Our network priorities

Chief Street

First Street to Fourth Street extension

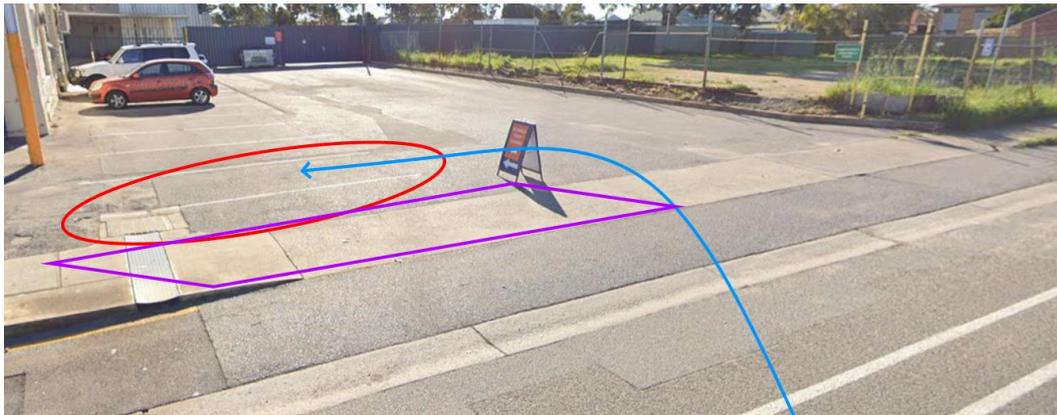
BISA proposes removing on-street parking on the eastern side in this section, enabling footpath widening, tree planting and a bike facility that allows for cyclist over-taking; as per the following generalised layout.

The 0.7m buffer on the eastern side is adequate for a buffer between a bike facility and traffic lane. It is inadequate to host rubbish bins, on the basis that the lack of land uses on the eastern side is such that this capability is not required. If this *is* required, the tree/verge area between trees on the western side could be provided at 1.2m (resulting in some deviation of the bike facility at tree locations, but noting that there are only 3 street trees currently in this section); and the buffer to parking at tree locations could be reduced to 0.7m, and a vertical element introduced to introduce surety against car door opening.
